September 13, 2013

Re: **ENERGY STAR for Windows, Doors, and Skylights – Version 6.0 Proposed Product Specifications**

**EPA ENERGY STAR V6 Final Payback in Northern Zone  
Comparison to Industry Estimate Using Assumed EPA  
Background**

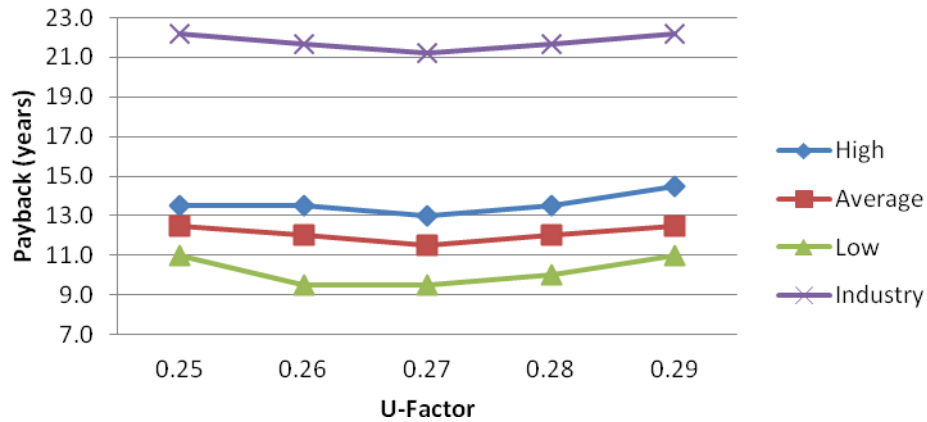
The following chart incorporates industry data into the EPA Figure 8 analysis provided within the "Review of Cost Effectiveness Analysis." This analysis clearly illustrates that Northern Zone paybacks at the EPA proposed 0.27 U-factor soar to an average of 21 years, far exceeding 2010 ENERGY STAR payback periods - and aggressively dismissing the consumer expected payback period of 6-10 years. The staggering 65% - 110% difference between the industry and EPA analysis must be viewed as an indication of the skewed results of the initial analysis.

**Comparison of ENERGY STAR Payback Period from V.6 Drft 1  
February 2013 and V.6 Final August 2013 Based on Same Data**

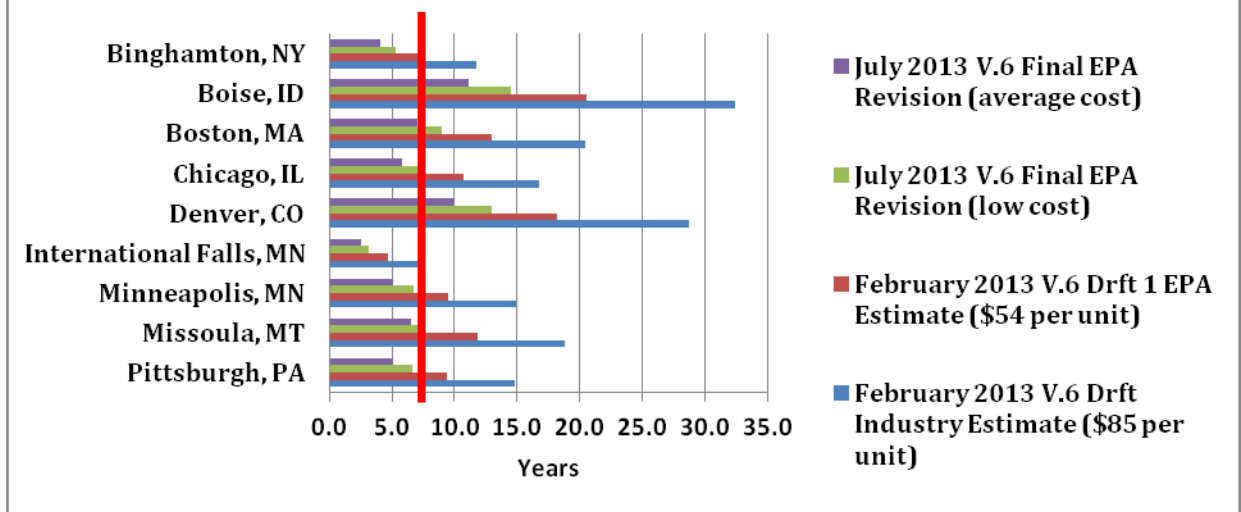
The preceding chart further exhibits the vast discrepancy in payback calculations between EPA and Industry. When developing the ENERGY STAR 2010 criteria, the EPA frequently pointed to the significantly reduced payback calculations as an incentive for consumers to invest in energy-efficient products. During that timeframe, EPA also heavily relied on the substantial 30% tax credit available in 2009-2010 to incentivize consumers to purchase ENERGY STAR products at premium costs. (The following statement excerpted from *U.S. DOE Partner Resource Guide August 2009*.)

EPA v.6 Final and Industry Payback Comparison for Half-lite Doors with consumer expected payback of seven years indicated with a red line.

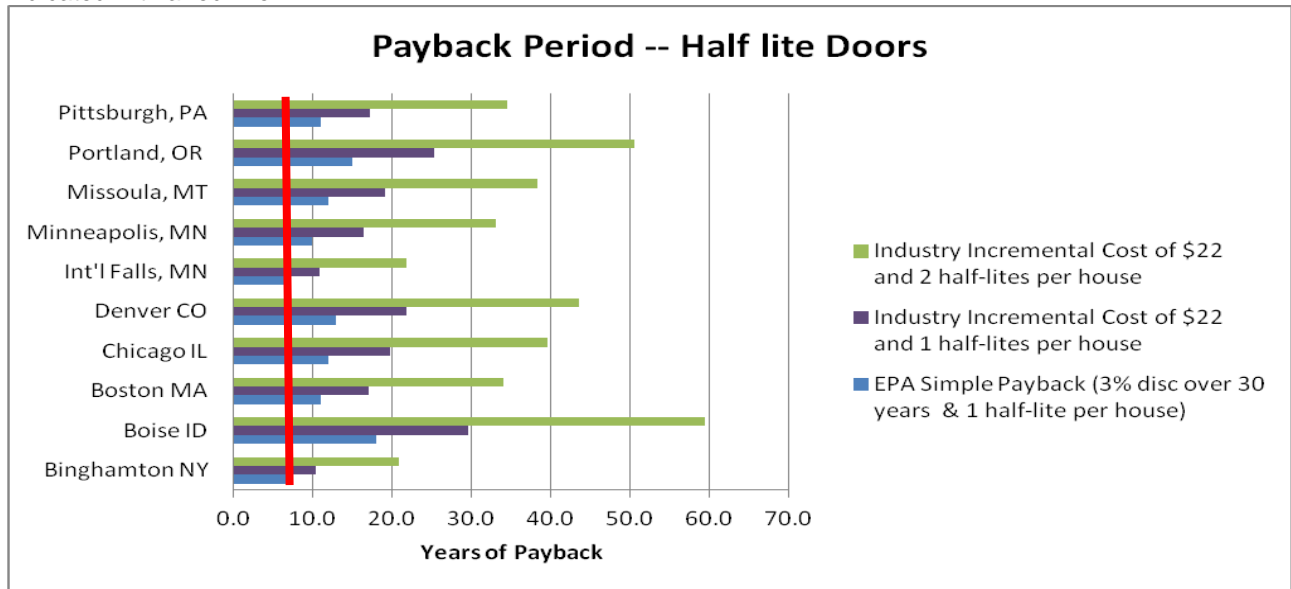
In addition, EPA indicates there will be minimal incremental cost for half-lite door changes, but analysis by door manufacturers (illustrated in the following chart) indicates the cost is nearly double the EPA estimate.

There should be no change to half-lite doors, as there are no energy savings with reasonable payback to the consumer. For example in Boise, which is a heating dominated climate, the payback period is 18 years by EPA v.6 final estimates, and 60 years by Industry estimates. Neither payback estimate is acceptable for consumers.
